CPSES-200102851
Log # TXX-01196
File # 10010.1
905.2

SUBJECT: COMANCHE PEAK STEAM ELECTRIC STATION (CPSES)
DOCKET NOS. 50-445 AND 50-446
SUPPLEMENT TO RELIEF REQUEST B-1 AND C-1
FROM INSERVICE INSPECTION REQUIREMENTS
(1986 EDITION OF ASME CODE, SECTION XI, NO ADDENDA;
UNIT 1 SECOND INTERVAL, FIRST PERIOD, FIRST OUTAGE
DATES: AUGUST 3, 2000 TO AUGUST 3, 2010)

LIMITATION AND WELD PROFILE EXAMINATION DATA

PLANT COMANCHE PEAK UNIT 1 SKETCH TBX-1-2100 Rev 2
SYST/COMP PRESSURIZER WELD IDENT. 13 RELATED TO WT PROCEDURE Tx-IST-210 Rev 3
EXAMINER John D. Harkins, Jr. George A. Thorne DATE 10-14-96

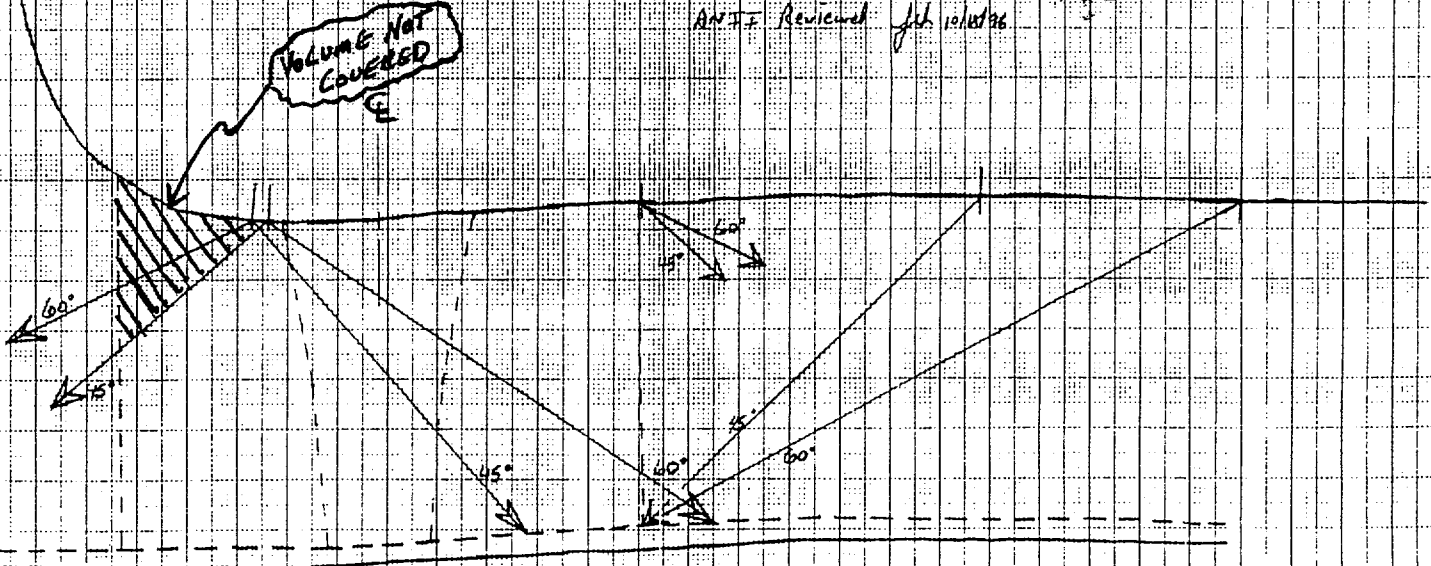
- 3) The weld profile sketches list three different coverage percentages at the bottom - which one applies?

4) Sketches do not show areas of incomplete coverage

They all apply. See below:

26 % REQUIRED EXAMINATION VOLUME NOT COVERED.

93 % REQUIRED EXAMINATION VOLUME COVERED IN AT LEAST ONE BEAM PATH DIRECTION WITH TWO BEAM ANGLES

96 % REQUIRED EXAMINATION VOLUME COVERED IN AT LEAST ONE BEAM PATH DIRECTION WITH ONE BEAM ANGLE

Previous sketches provided show the incomplete coverage. The area not covered begins left of the centerline at the start of the 60 ° beam angle. A shaded area figure, which depicts area not covered, is being provided in the attachment.
